**Citizen Comment Sheet  
SE 4<sup>th</sup> St Improvements Public Meeting  
January 28, 2016**

Subject: SE 4<sup>th</sup> design

Figure 2. The distances between the roundabouts are as follows based on Google Earth (See Question #2 below):

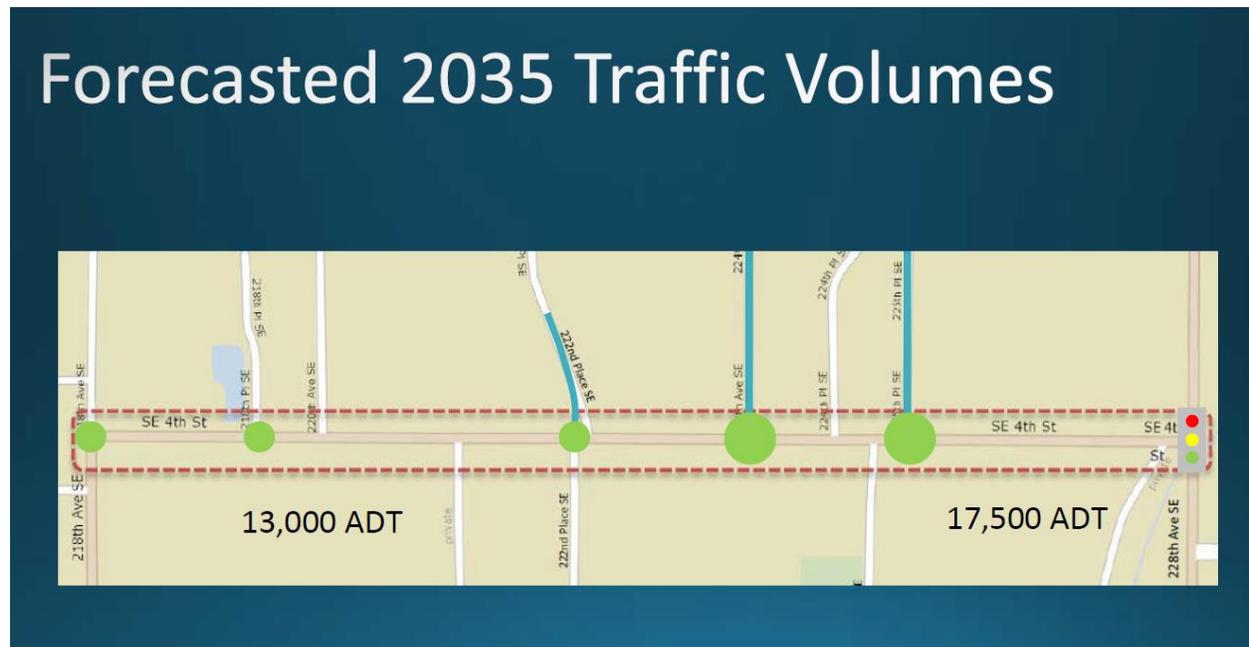
Member Odell correctly raises the issue of essentially eliminating part of the important and *highly* limited east-west grid access through the proposed design of five roundabouts.

Member Malchow raises the question of EF&R response time. Emergency services and especially the fire department don't like roundabouts or traffic circles because of the response time reduction.

Figure 3.

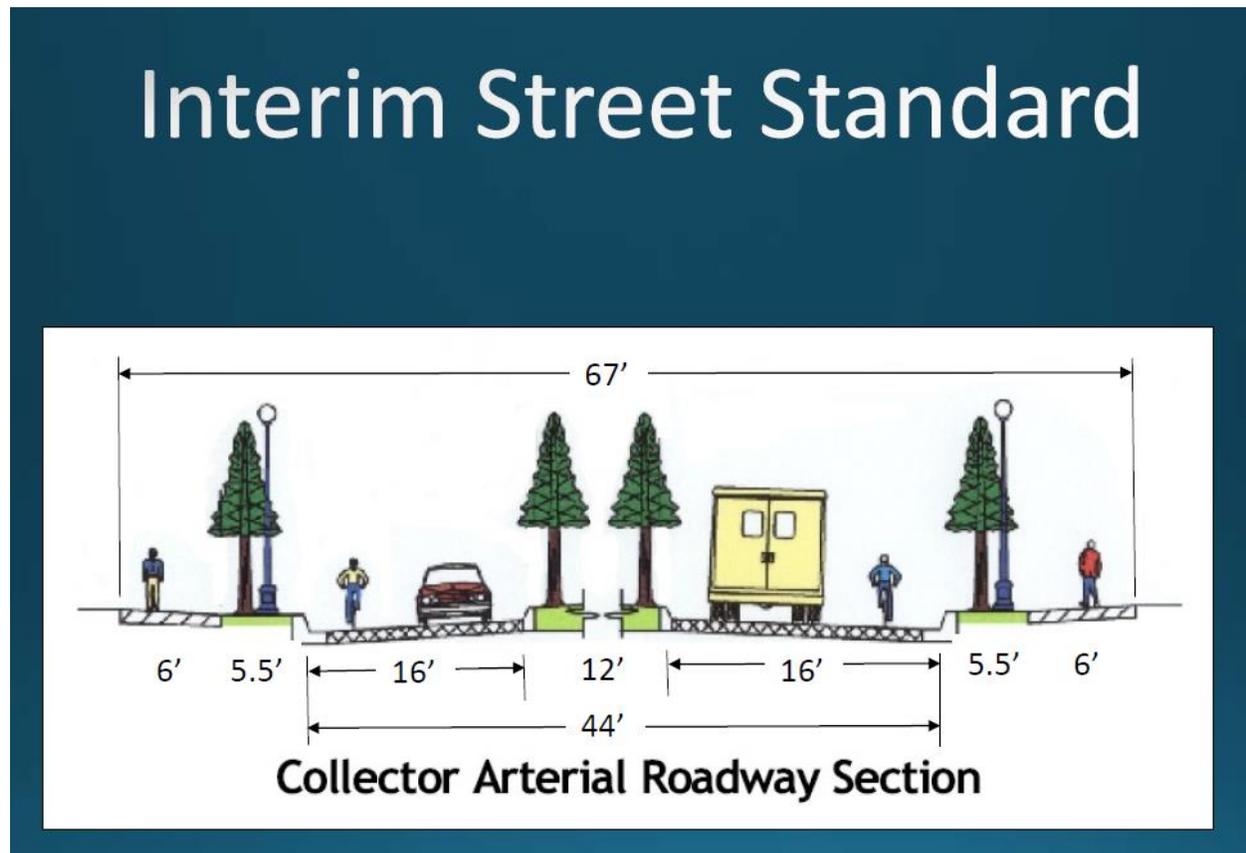
The sidewalk along the east side of 228<sup>th</sup> is 12 ft. The width in Figure 1 is 17 ft. I suggest that the width in Figure 1 could be reduced to something closer to 228<sup>th</sup>, allowing bike lanes. (See Figure 3.)
